Service Information XZS182

Different design - same function

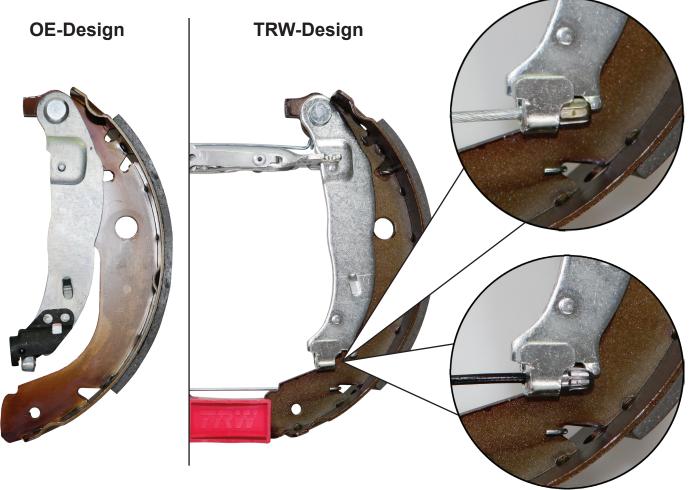
The TRW design, for the parts shown below, is different to the OE design. Whilst the visual appearance has changed, the fitting/function is the same.

Both designs are suitable to repair/maintain the brake.
